VALUE ENGINEERING CHANGE PROPOSAL
MISSOURI DEPARTMENT OF TRANSPORTATION

Contract ID 101217-503 **Job No.** J5S2179

MoDOT - RTE. 242 - MILLER/CAMDEN CO.
Conceptual VECP Proposal Submittal Data
Bloomsdale Excavating Co., Inc.
W. By-Pass Rte. MM

The contractor proposes to reconfigure the new Route MM stage 1 bypass in such a way as to eliminate the need for the stage 2 bypass.

STATE OF MISSOURI
JASON R. MACKENZIE
NUMBER
PE-2003036049
PROFESSIONAL ENGINEER

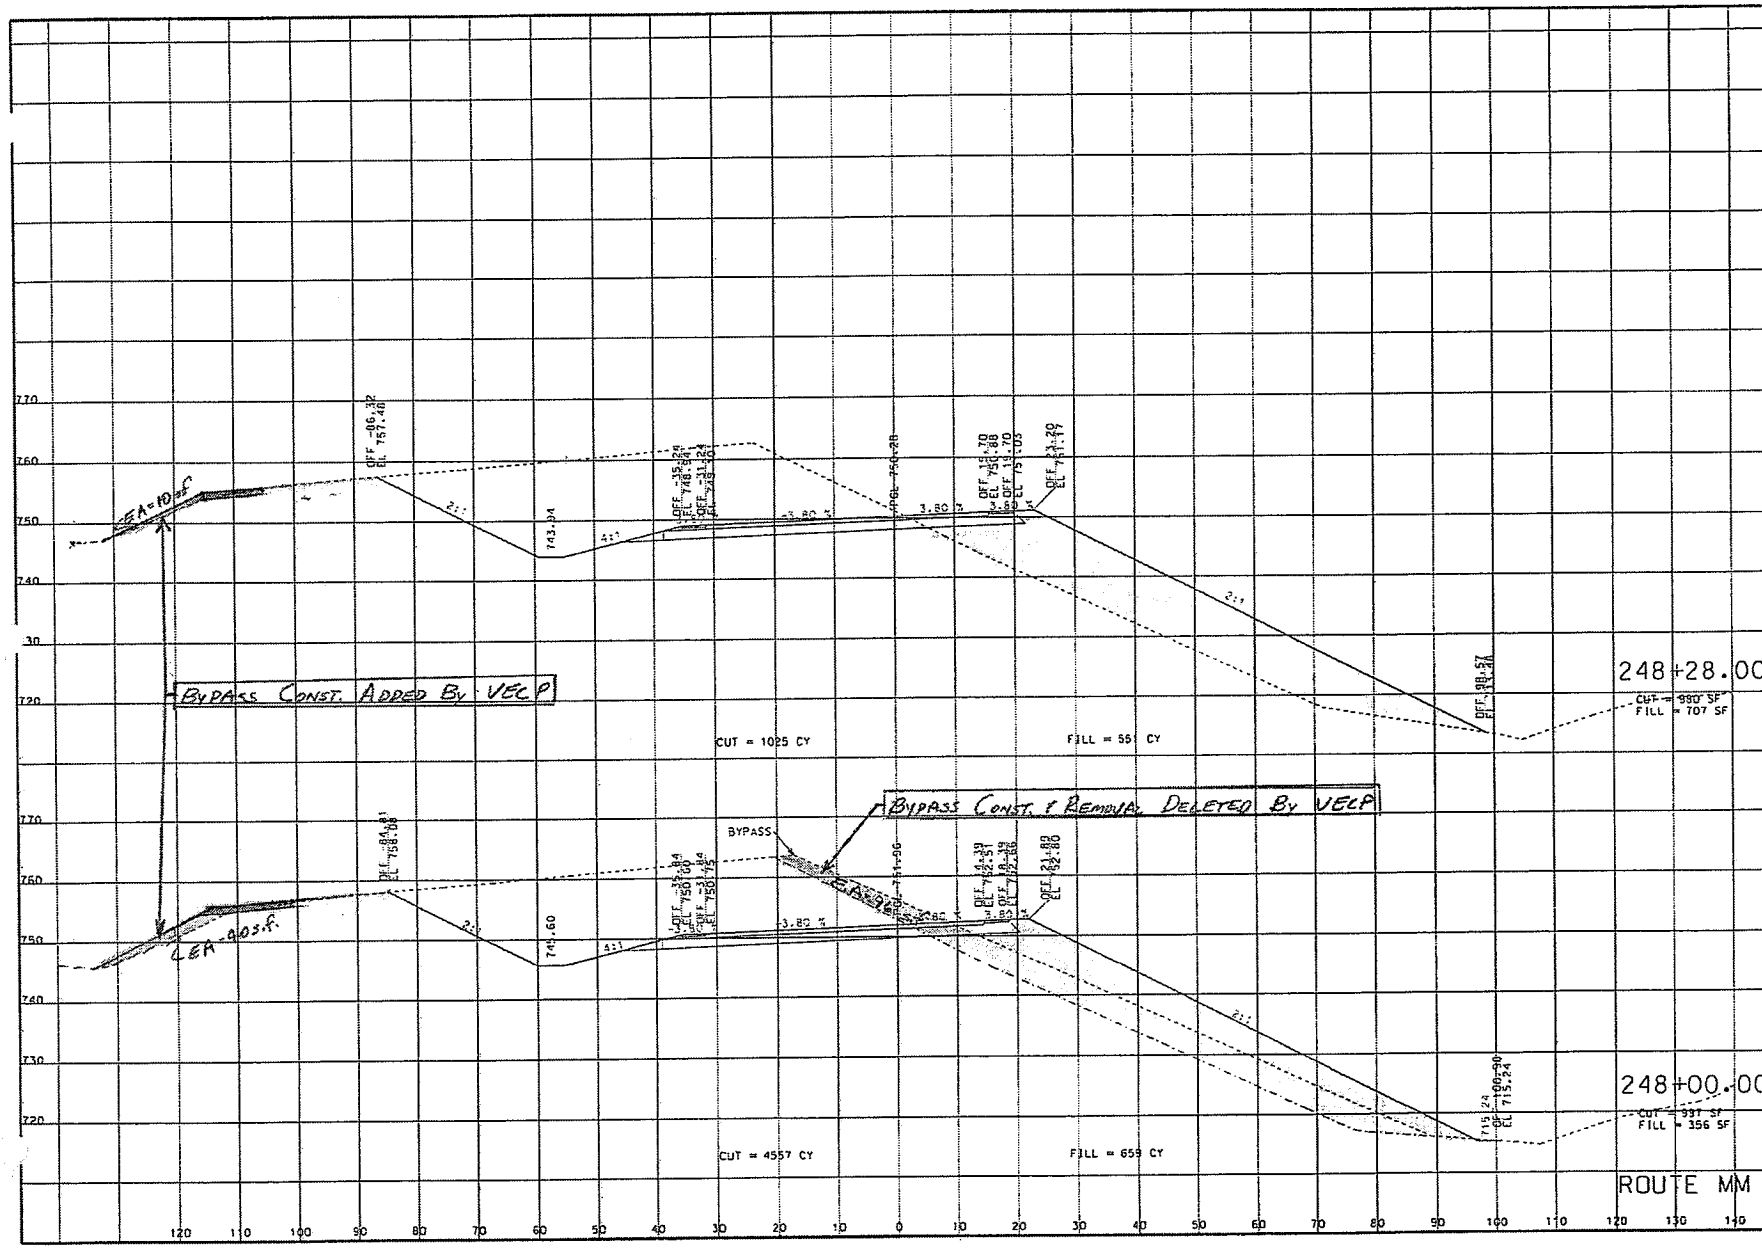
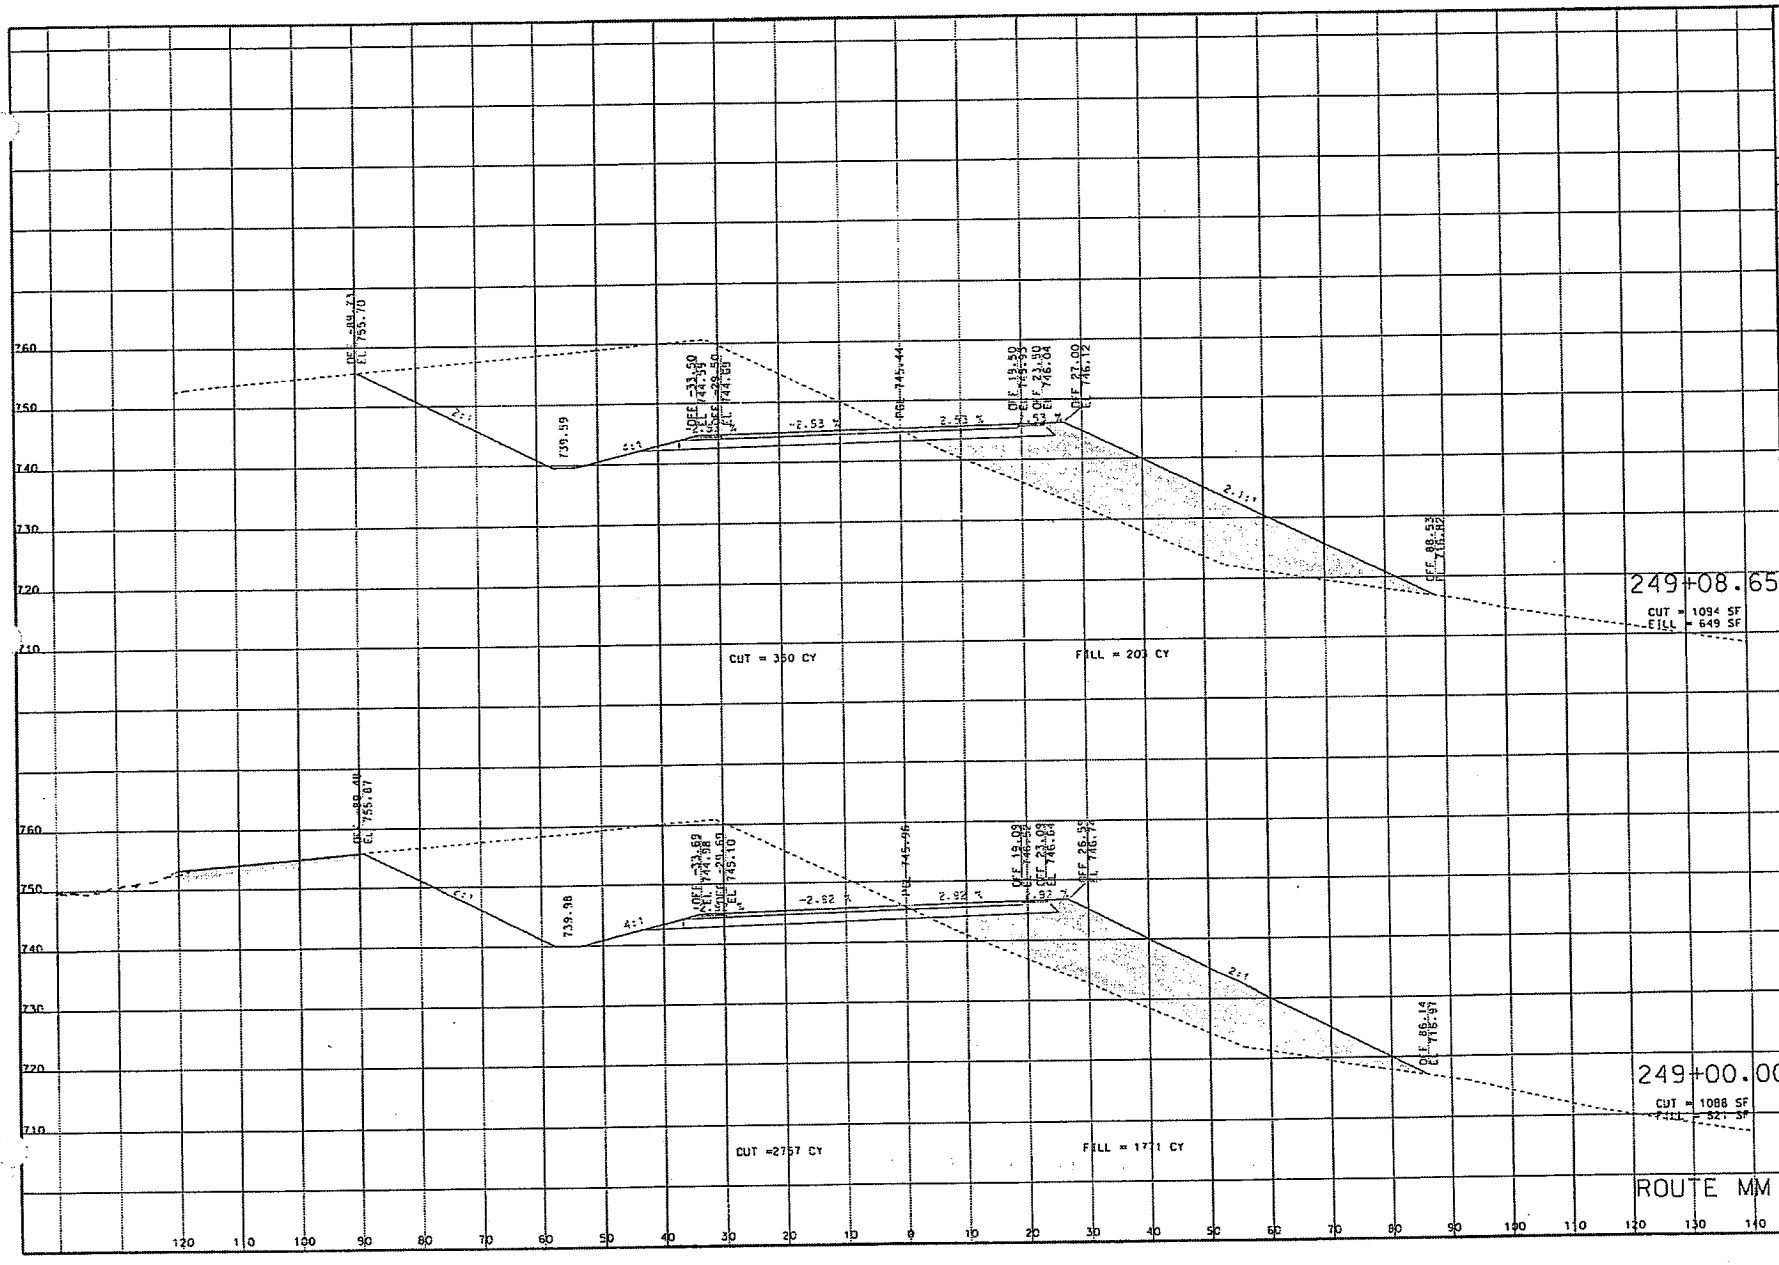
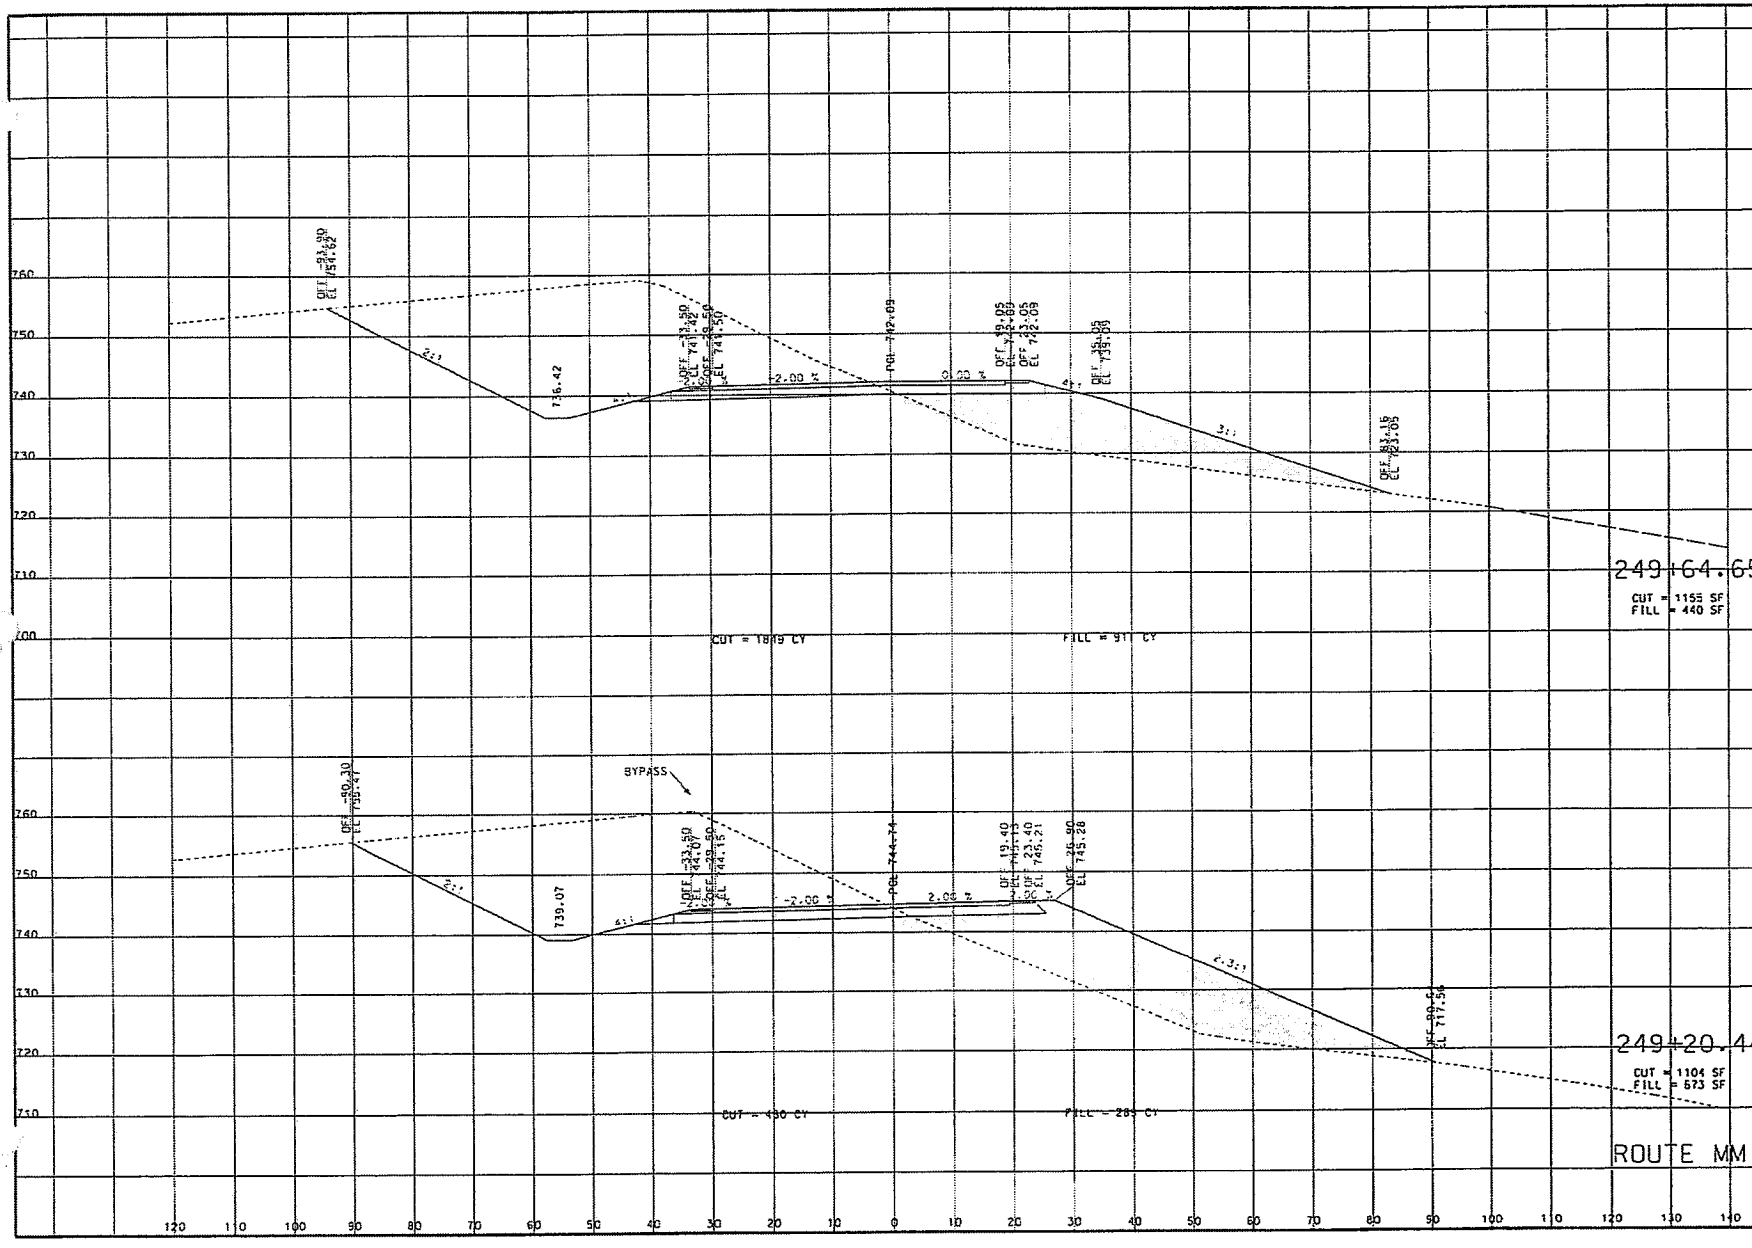
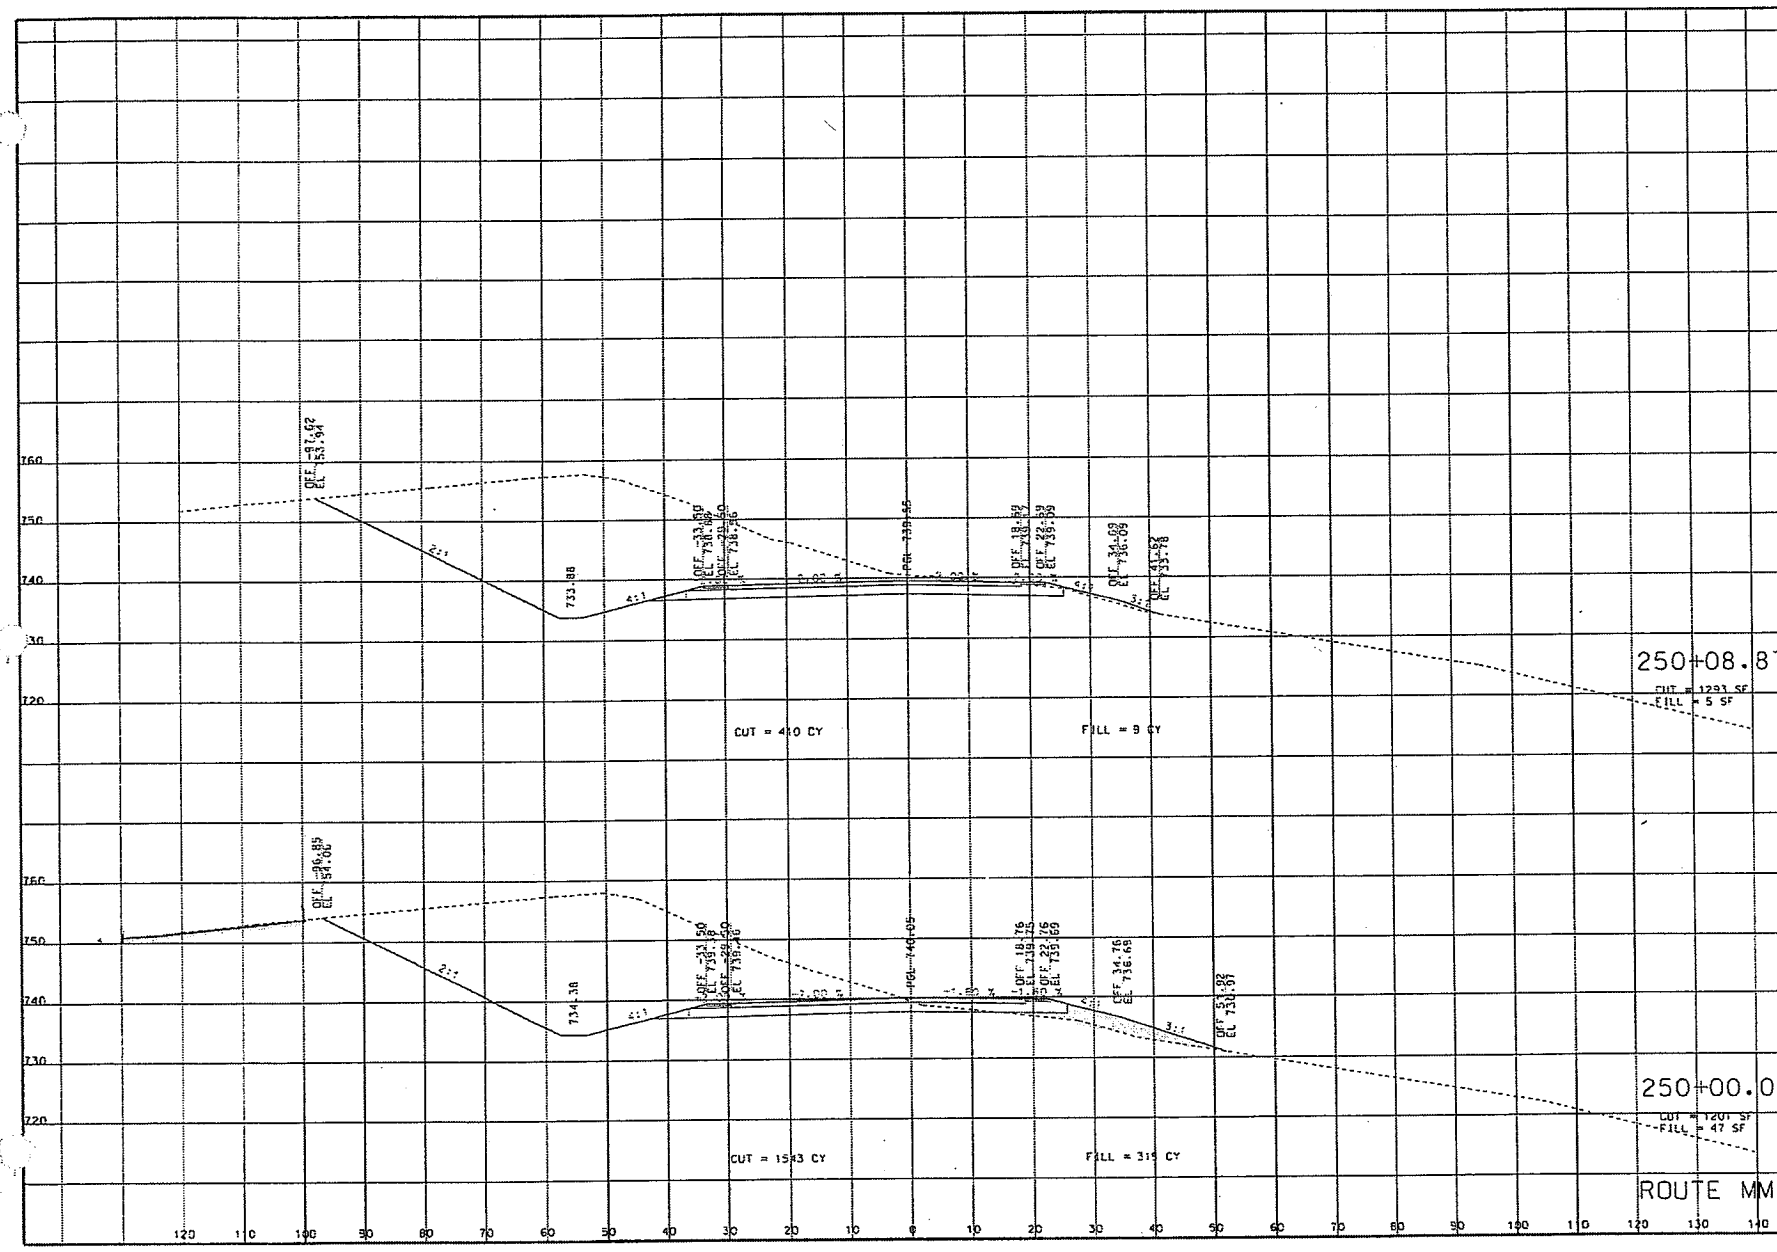
Note: ***See attached x-section sheets with deleted area shaded in red.***

Note: ***See attached x-section sheets with the revised fill quantity shaded in yellow.***
